2CAN091002

September 16, 2010

SUBJECT: Request for Additional Information
Technical Specification Changes and Analyses Relating to
Use of Alternative Source Term
Arkansas Nuclear One, Unit 2
Docket No. 50-368
License No. NPF-6

**Response to Request for Additional Information
Related to the Use of Alternative Source Term (AST)**

NOTE:
Release point circled in red.
Control room intakes (receptors) are shaded.

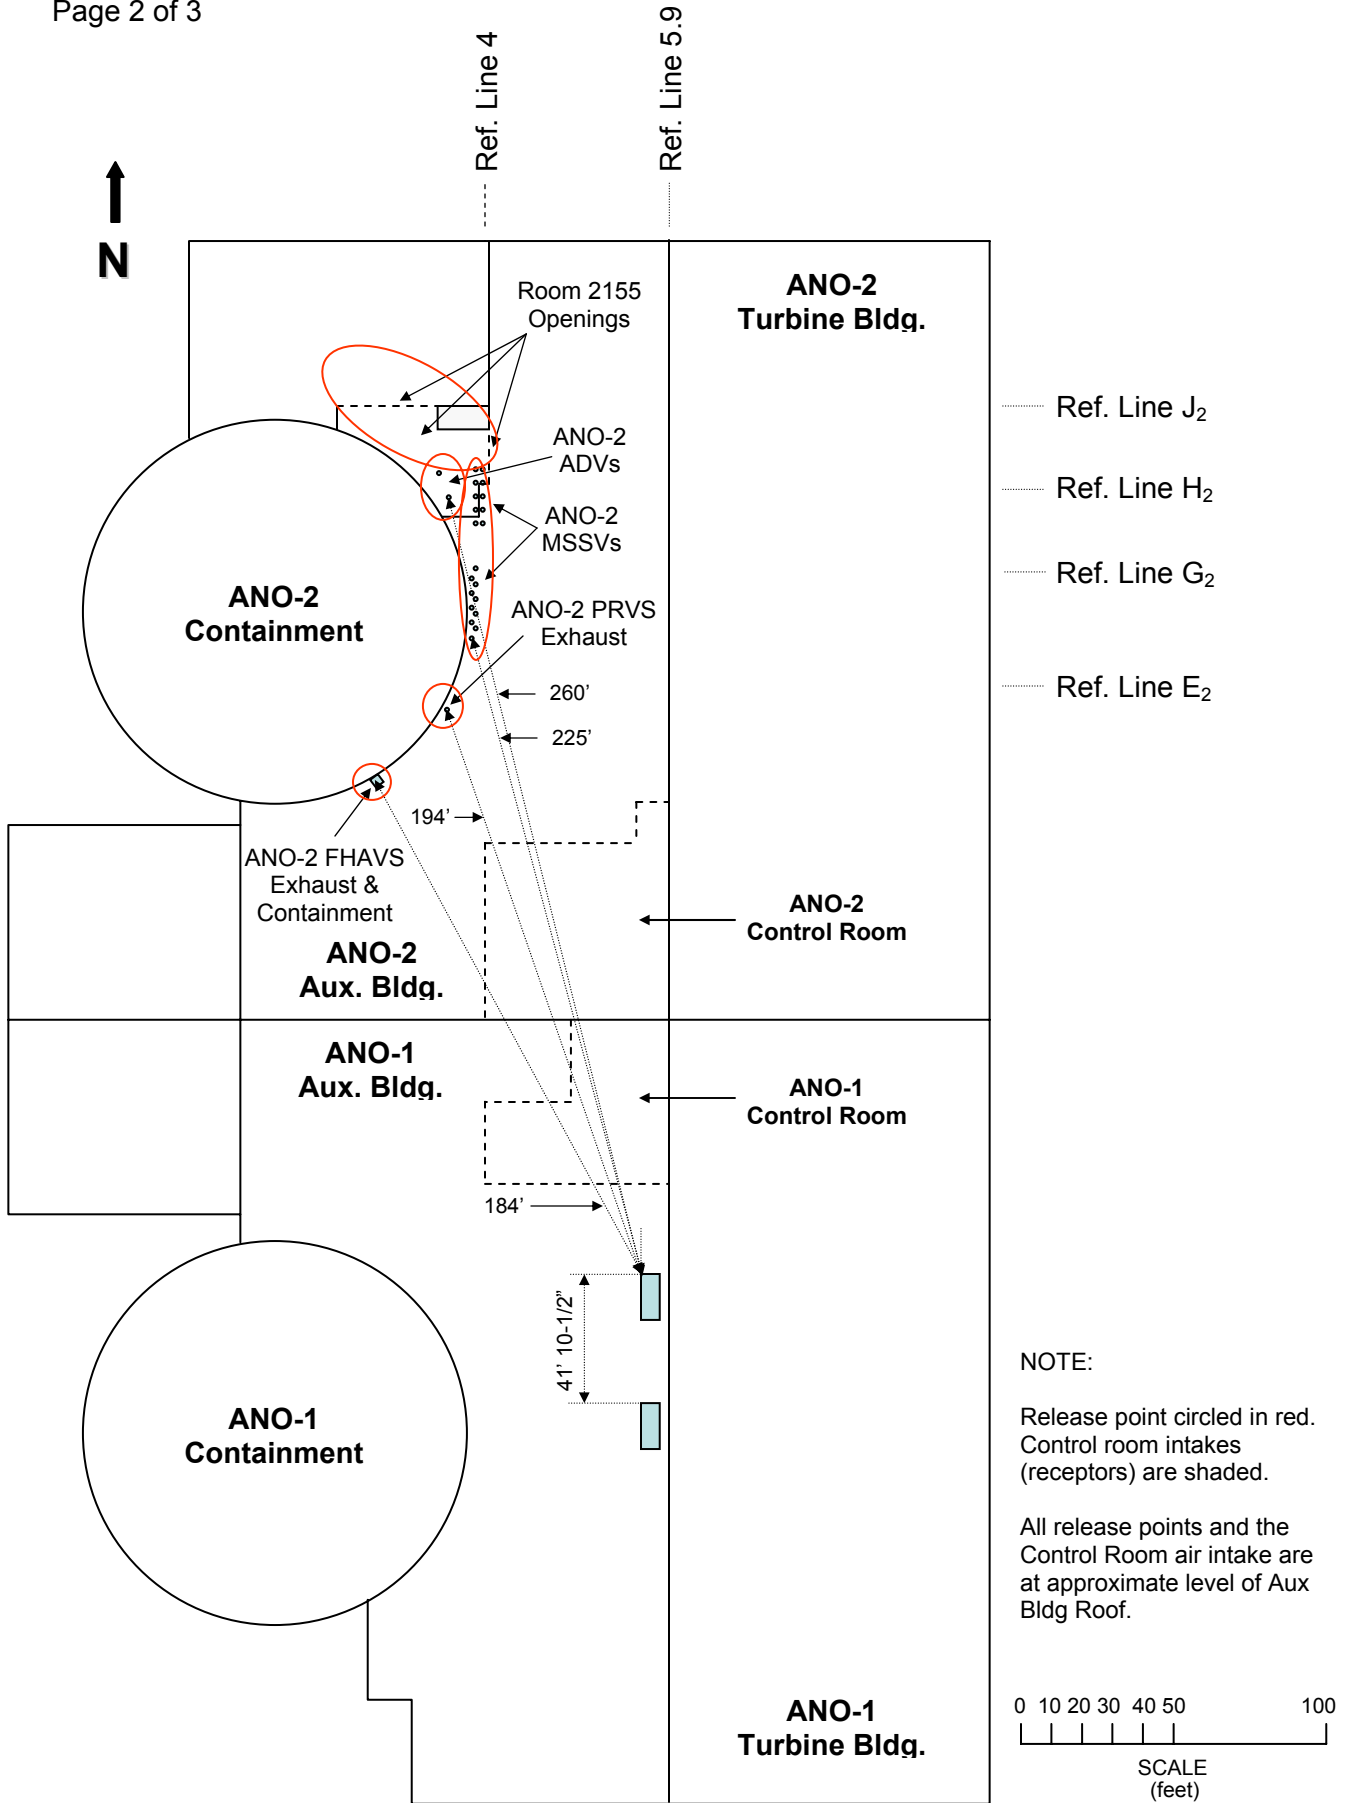
- 2. Attachment 3 provides a series of figures showing the position of each postulated release location with respect to key plant structures and the control room intakes. The figures are very informative, but they do not appear to be drawn to scale. Please provide one scaled aerial-view drawing from which distance and direction inputs can be reasonably approximated. Indicate true north and provide the scale of the figure. Highlight all postulated sources and receptors and outline the location of the control room envelope.**

The following page contains a scaled overhead view of applicable release points in relation to key plant structures and the control room intakes. Distances between release points and the nearest control room intake are also approximated. Note that the illustrated distance between the Fuel Handling Area Ventilation (FHAV) exhaust and the Penetration Room Ventilation System (PRVS) exhaust with respect to the nearest control room intake are conservative, given at control room intake level; however, these systems actually exhaust more than 83 feet above the Auxiliary Building roof.

As requested, the illustration displays the direction of true north and postulated release points are circled. In addition, the control room envelope is also outlined.

All release points and the Control Room air intake are at approximate level of Aux Bldg Roof.
